AMENDMENTS

IN THE DRAWINGS:

FIG. 5

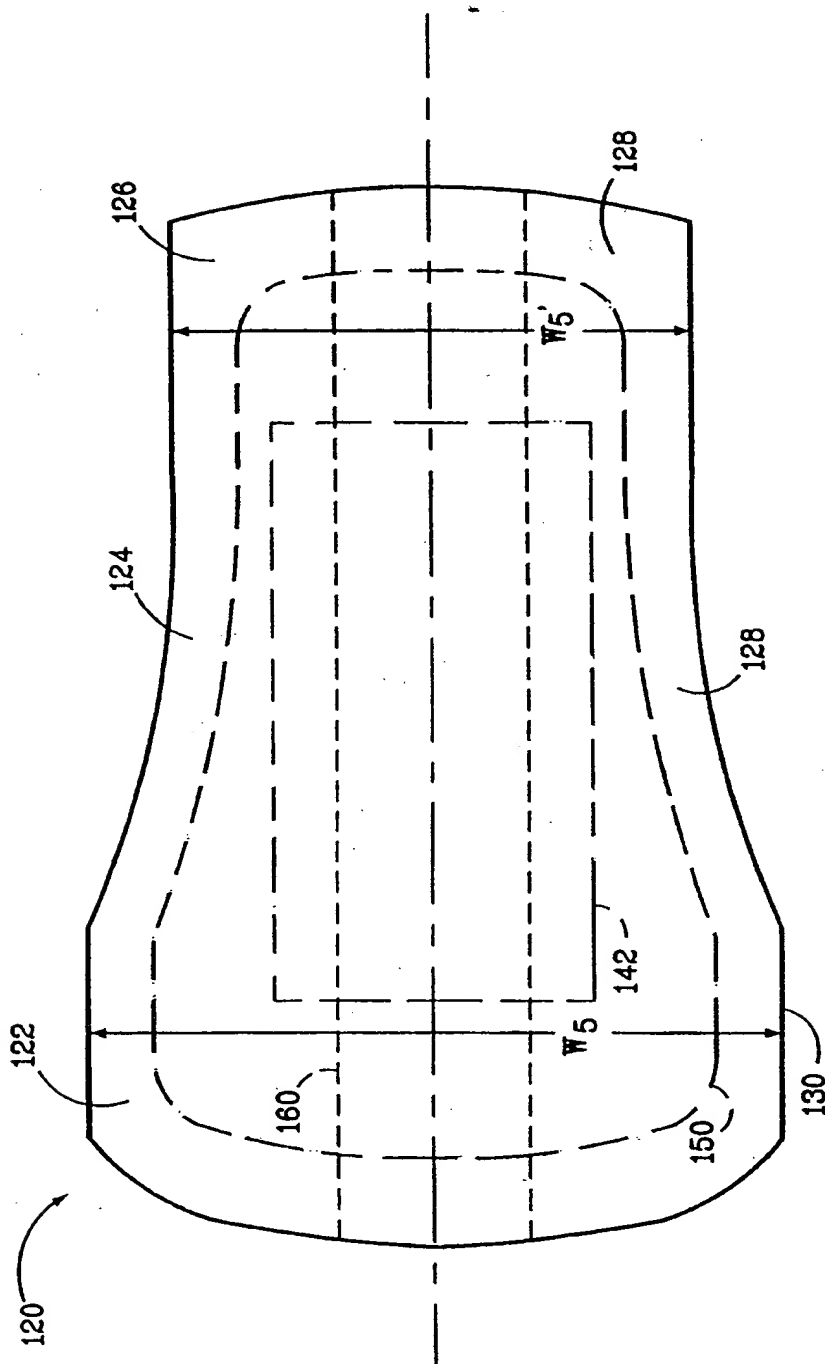
In Figures 2, 3, and 5, the outlines of structures 42, 50, 60, 142, and 150 have been amended to include a dashed line, rather than a solid line. The dashed lines denote underlying structures. The amended drawings are attached hereto.
